UNITED STATES PATENT AND TRADEMARK OFFICE

APPLICATION NO.	FILING DATE	FIRST NAMED INVENTOR	ATTORNEY DOCKET NO.	CONFIRMATION NO.
10/070,076	03/01/2002	Aritaka Ohno	KP0147	7254

Office Action Summary

DETAILED ACTION

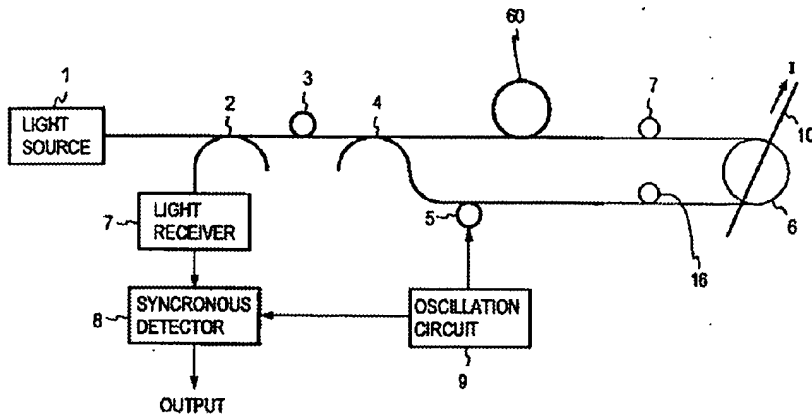
As for claim 1, the prior art disclosed by the Applicant shows a current sensor using a Sagnac interferometer including a light source (1), an optical directional coupler (2) on which light from the light source impinges, a first polarization filter (3) on which light emitted from the optical directional coupler impinges and which emits a given linearly polarized light, a second optical branch unit (4) for branching light emitted from the first polarization filter into two beams, an optical phase modulator (5) connected to one branch end of the second optical branch unit, a current sensing coil (6) on which light from the other branch end of the second optical branch unit and light from the optical phase modulator impinge as levorotatory light and dextrorotatory light, a first quarter-wave plate (16) inserted between the optical phase modulator and the current sensing coil, and a second quarter-wave plate (7) inserted between the other branch end of the second optical branch unit and the current sensing coil.

The disclosed prior art does not show a first depolarizer inserted between the optical directional coupler and the first polarization filter.

FIG. 2

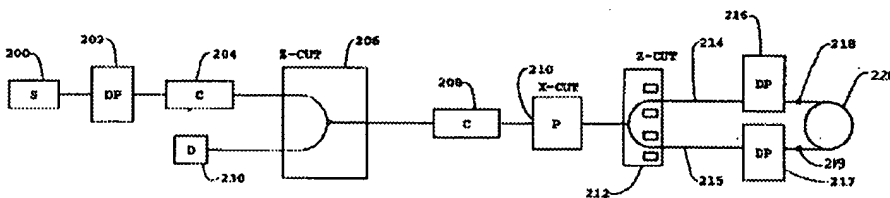
Page et al (Page hereinafter) show a Sagnac interferometer using a depolarizer (202) in between the light source (200) and a polarization filter (210).

At the time of the invention, one of ordinary skill in the art would have modified the Sagnac interferometer of the disclosed prior art with a first depolarizer inserted between the optical directional coupler and the first polarization in order to improve the efficiency of the first polarizing filter as taught by Page on column 2, lines 56+. Page teaches that a depolarizer with a polarizing filter improves the efficiency of the polarizing filter and that the placement of the depolarizer should be between the light source and the polarizing filter. Thus, suggesting to one of ordinary skill in the art that the criticality lies in that the light must be depolarized before entering the polarizing filter. Therefore, one of ordinary skill in the art would have placed the

Fig. 1

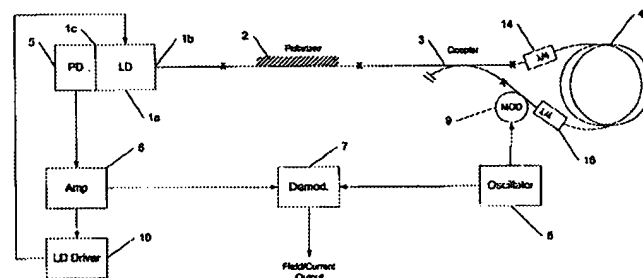
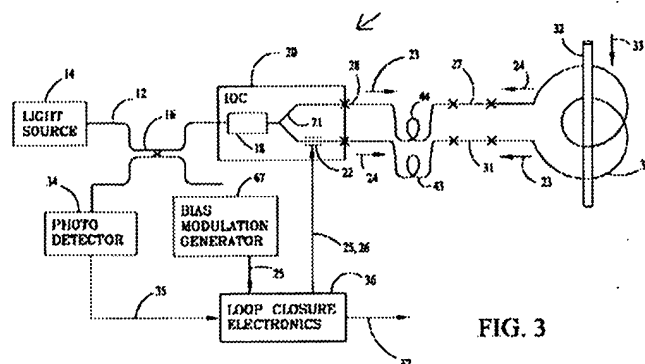
Bennett et al (Bennett hereinafter) show a Sagnac interferometer comprising a polarizer, coupler, $\frac{1}{4}$ wave plates, a coil, and a phase modulator wherein the light source is a light emitting diode.

At the time of the invention, one of ordinary skill in the art would have used a light emitting diode, which emits non-polarized light as disclosed by applicant, as the light source for the combined apparatus of the disclosed prior art and Page in order to provide light that is usable in the interferometer since Bennett teaches that light emitting diodes produce the proper type of light required in the Sagnac interferometer when used with a polarizer. Therefore, a skilled artisan would have used a non-polarizing light source in order to provide light to the interferometer.
